## SERVICE BULLETIN

SUBJECT: TS-120S FINAL PROTECTION

DATE 7/27/79

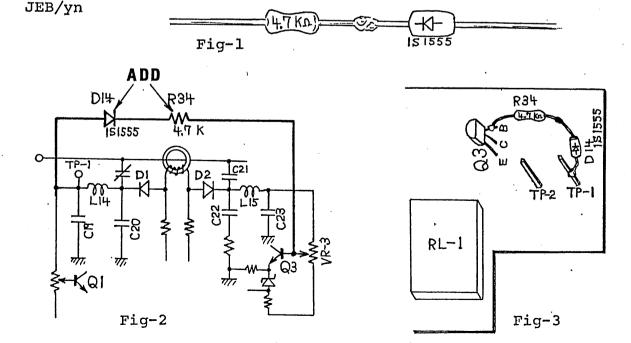
If for any reason work is performed in the Final unit, install two additional parts to the Filter unit X51-1200-00. This will improve protection action.

- 1. Remove top and bottom covers.
- 2. Remove Final unit (6screws).
- 3. Filter unit X51-1200-00 will be exposed. Install between Q3 Base, and TP-1, series wired diode and resistor D14 and R34.

New Part number D14 1S1555 V11-0076-05 R34 4.7K ohm
